SERVICE BULLETIN

M-1376A

2014.5 DYNA LOW RIDER IGNITION SWITCH BRACKET AND KNOB - SAFETY RECALL 0158

Figure 1. Ignition Switch

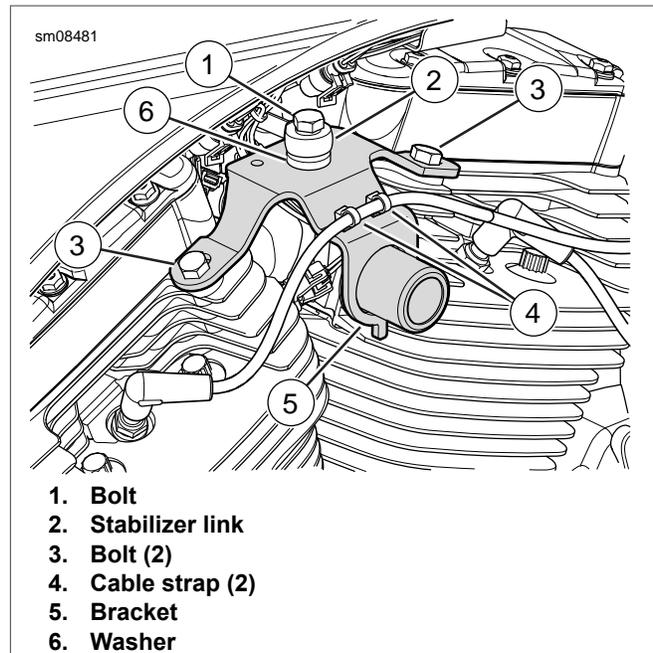
3. See Figure 1. Loosen set screw (6). Remove knob (5).
4. Remove nut (4) using IGNITION SWITCH SPANNER WRENCH (Part No. HD-50988).
5. Remove cover (3).
6. Disconnect connector from ignition switch.
7. Remove ignition switch (1).

1. See Figure 1. Install **new** bracket (8).
2. See Figure 2. Loosely install bolts (3).
3. Loosely install washer (6) and bolt (1).
4. Tighten bolts:
 - a. Stabilizer link bolt (1): 18-22 ft-lbs (24.4-29.8 Nm).
 - b. Ignition bracket bolts (3): 35-40 ft-lbs (47.5-54.2 Nm).
5. Install **new** cable straps (4).
6. See Figure 1. Install ignition switch (1).
7. Connect connector to ignition switch.
8. Install cover (3).
9. Install nut (4) using IGNITION SWITCH SPANNER WRENCH (Part No. HD-50988). Tighten to 140-160 **in-lbs** (15.8-18.1 Nm).
10. Install **new** knob (9). Tighten set screw (6) to 20-26 **in-lbs** (2.3-2.9 Nm).
11. Test ignition switch operation. See the service manual.
12. Install fuel tank. See the service manual.
13. Install seat. See the service manual.
